# NWDA APPEAL LU 16-100496 DZM MS BLOCK 290 SLABTOWN SQUARE

# BLOCK 290

# MASTER PLAN DEVIATIONS

# NEIGHBORHOOD PARK

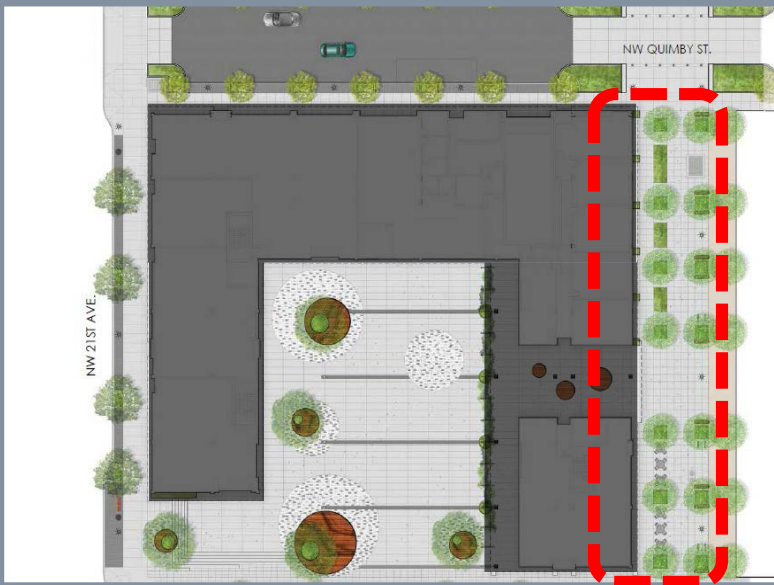
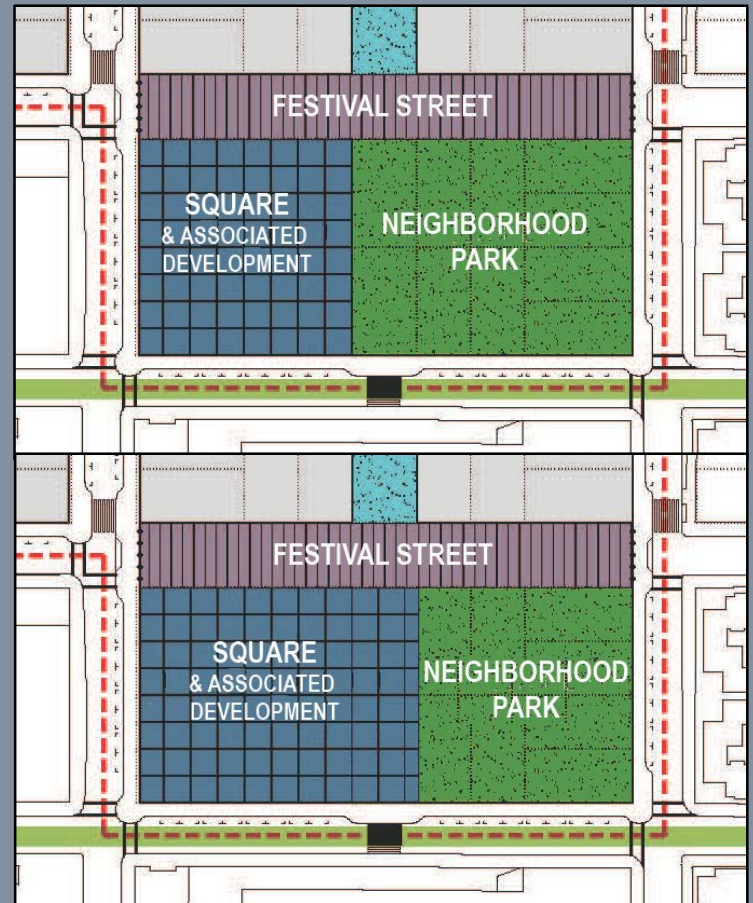
Master Plan Amendment approved to reduce the boundaries of designated public open space, and increase the boundaries of the private development site

Allowing a private building to encroach in a designated public space, ***is not consistent with the approved Con-way Master Plan's vision and purpose.***

# PUBLIC SQUARE STANDARD 10.A

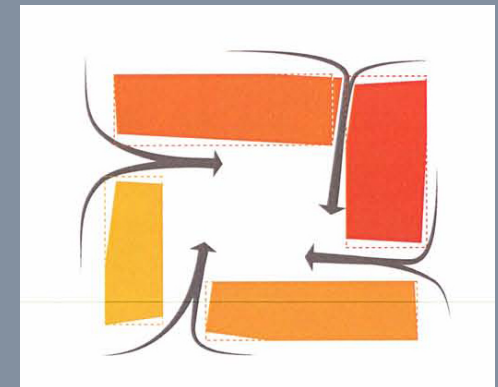
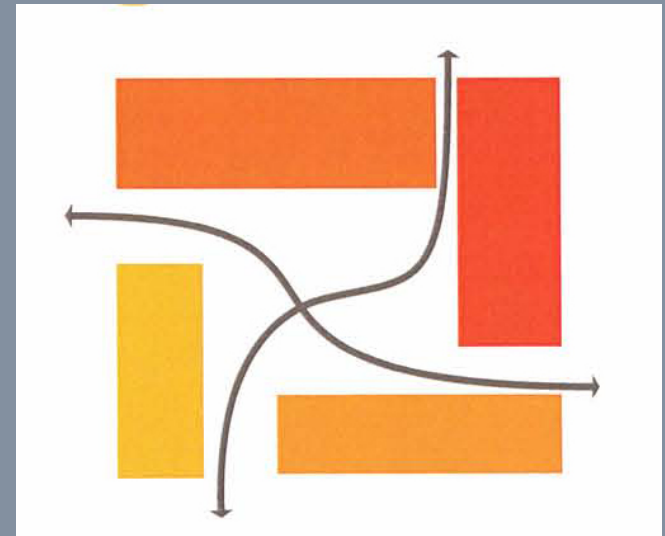
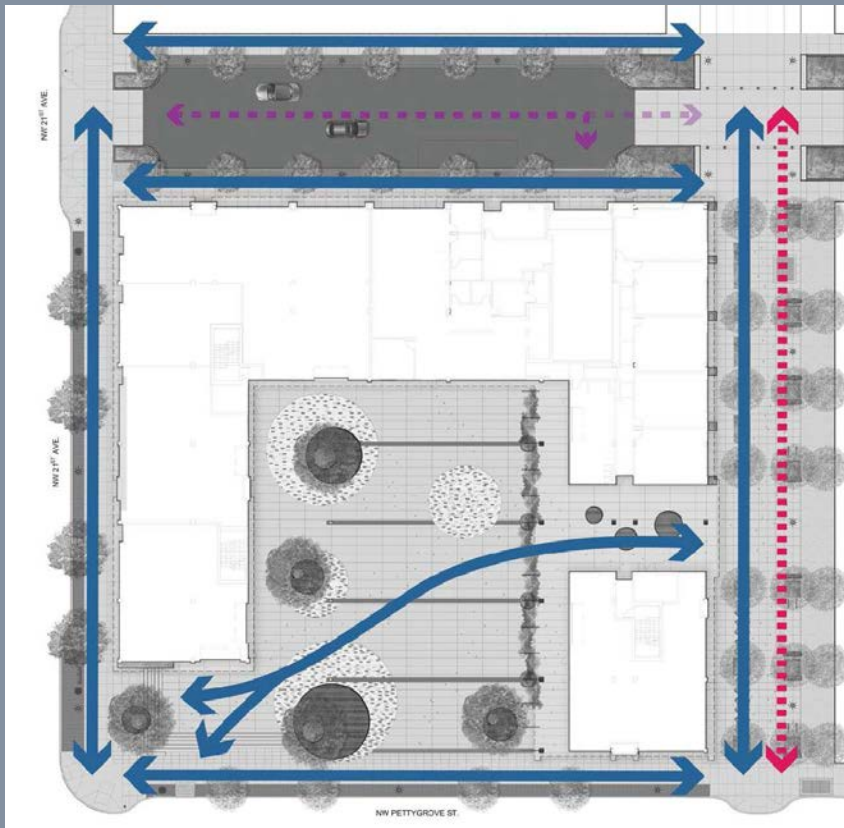
The square shall be a significant, iconic urban place, framed by active buildings on at least three sides, and **connected to nearby, open spaces**

# PUBLIC SQUARE STANDARD 10.B

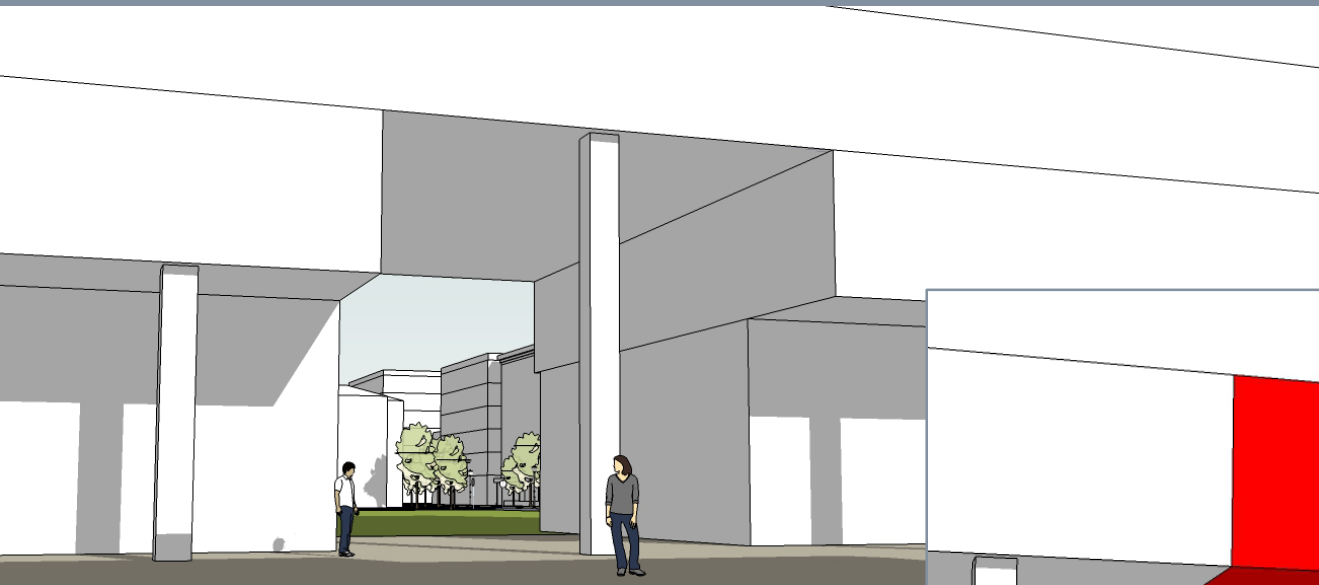
Modification approved to reduce the minimum required dimension of the square at the southwest corner from **100 feet to 31-1/2 feet**

A **narrower** square *does not* “better meet the Standard”  
An **18% smaller** square *does not* “better meet the Standard

# SLABTOWN SQUARE

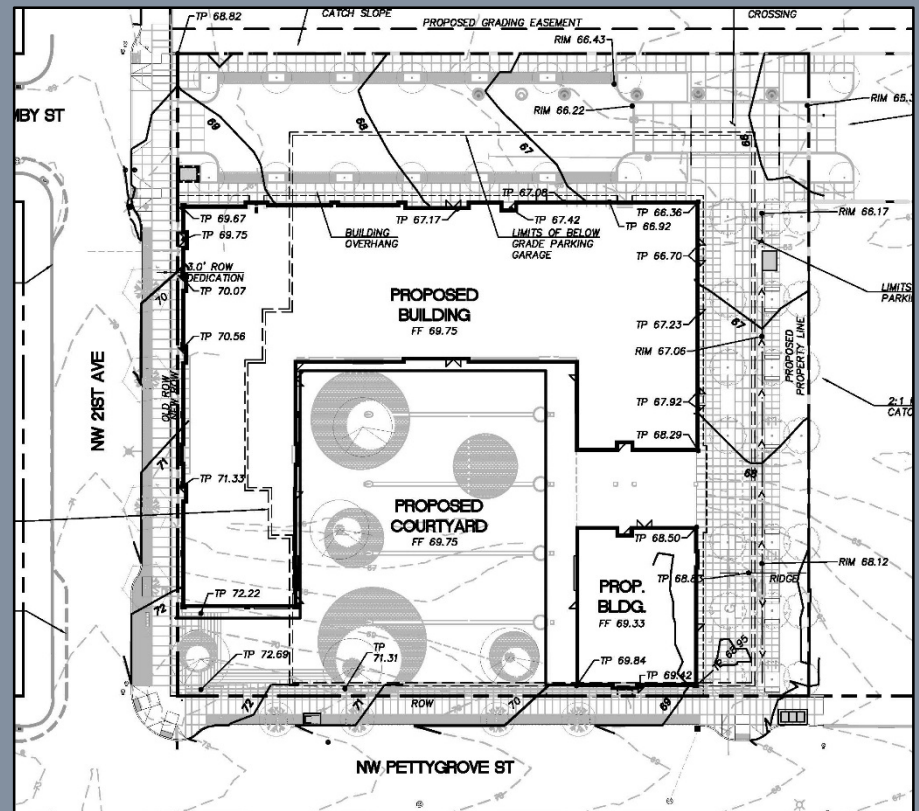
By not complying with numerous design standards, the proposal is

*turning the  
public “square”  
into a  
private courtyard.*

# PROPOSAL – APRIL 2017

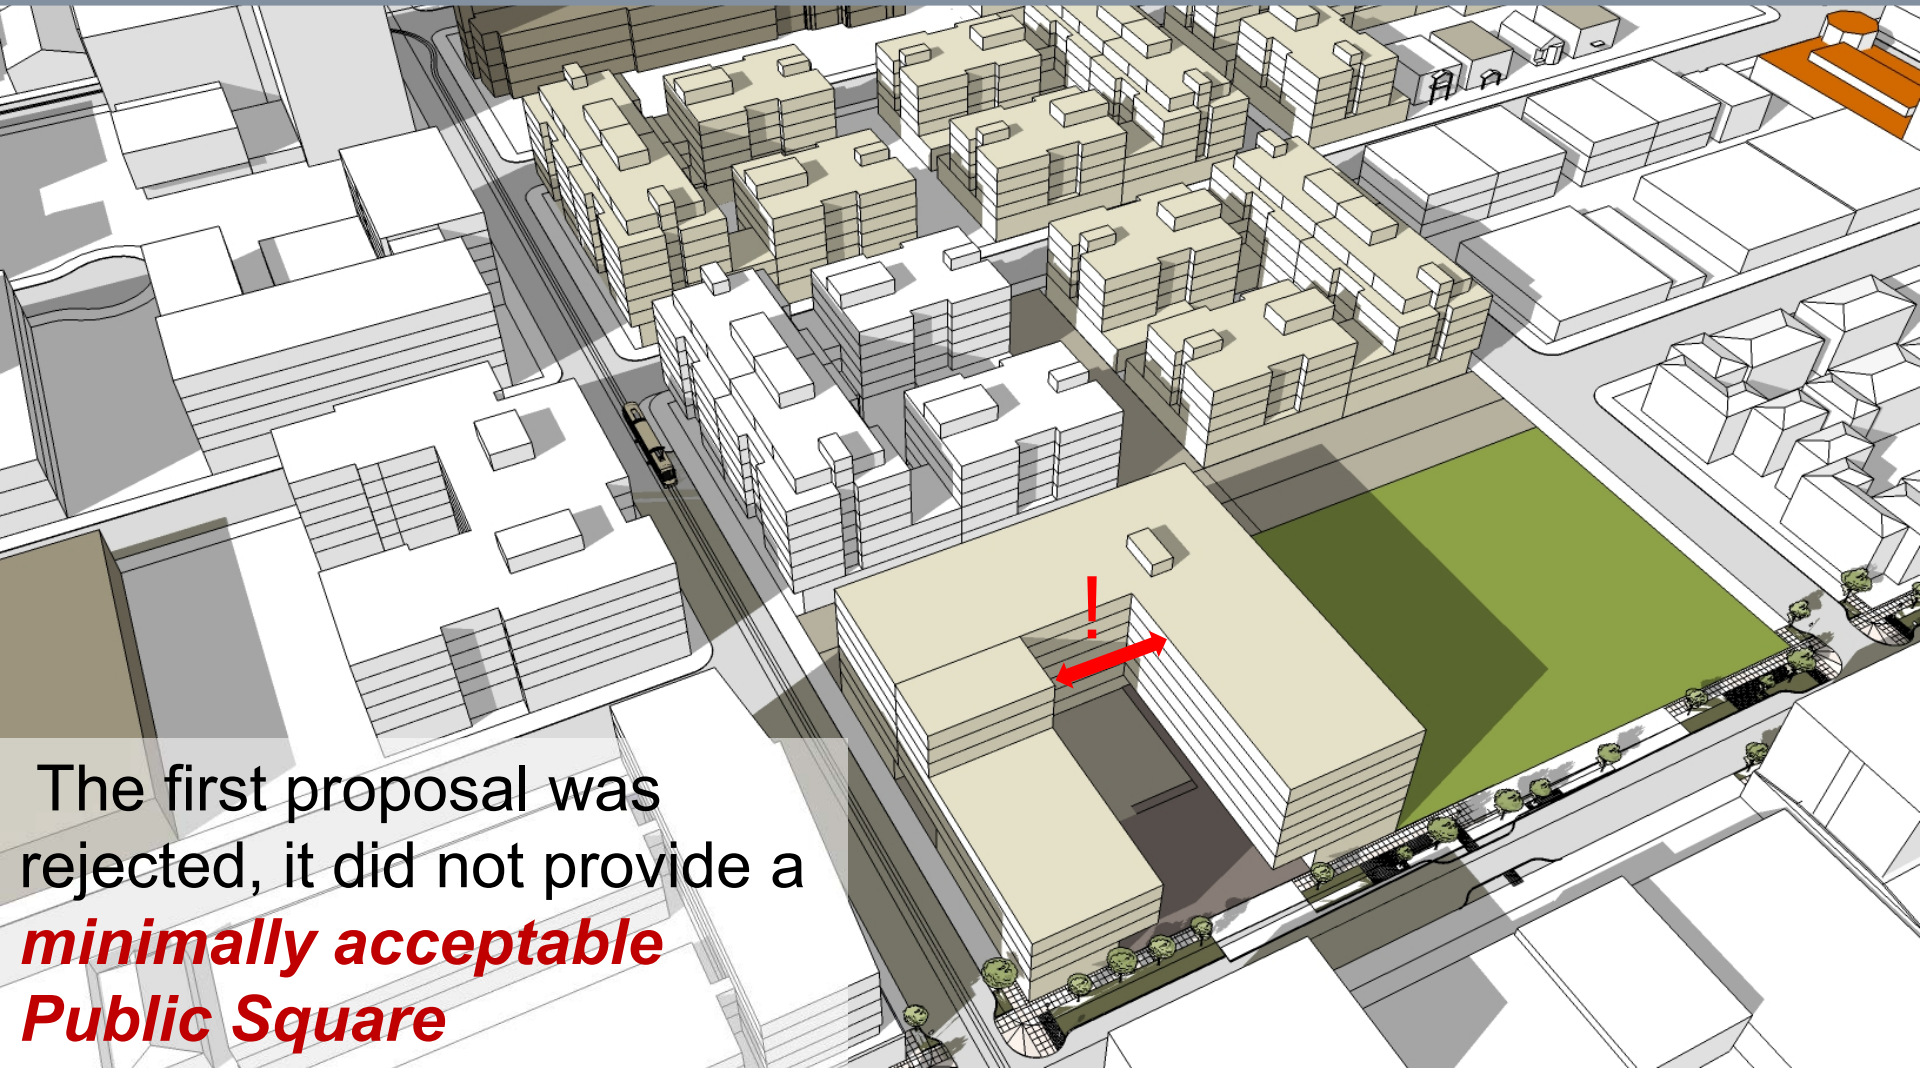
The first proposal was rejected, it did not provide a *minimally acceptable Public Square*

# PROPOSAL – JULY 2017

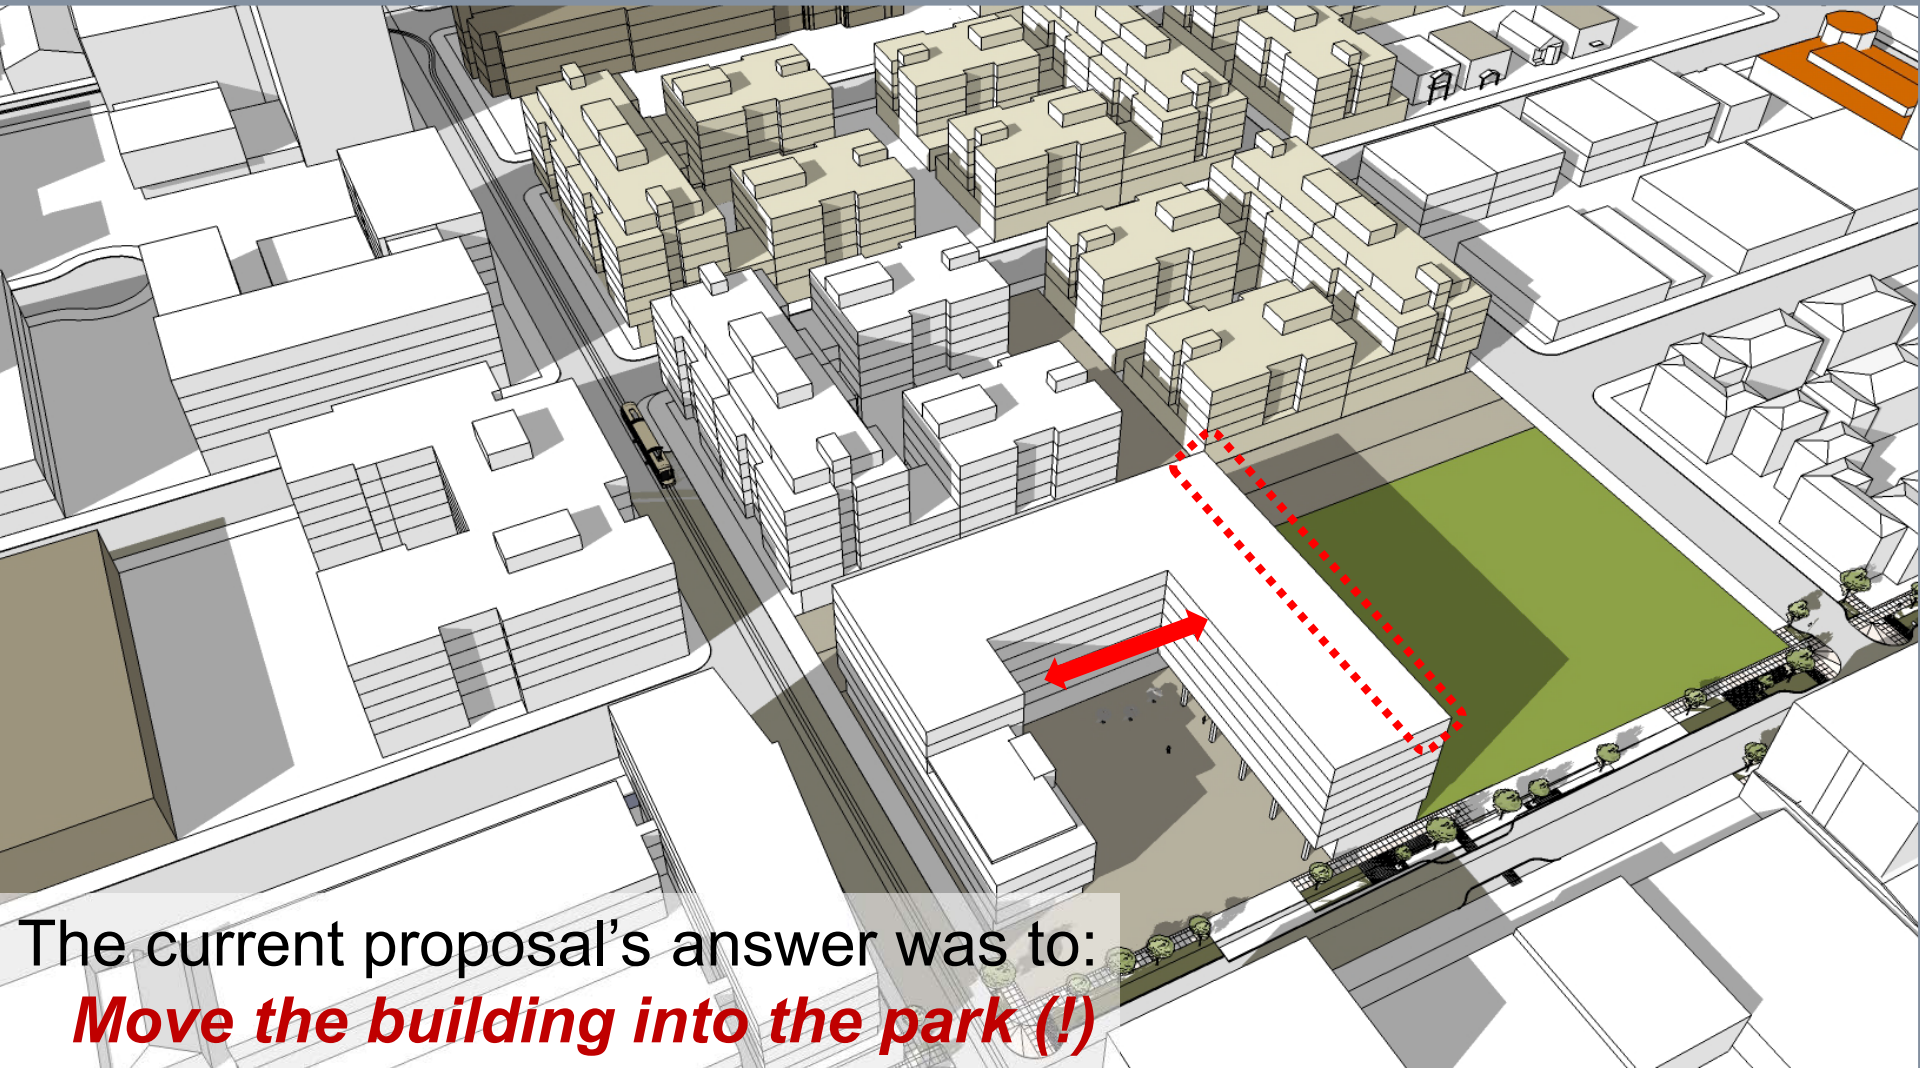
The current proposal's answer was to:  
***Move the building into the park (!)***
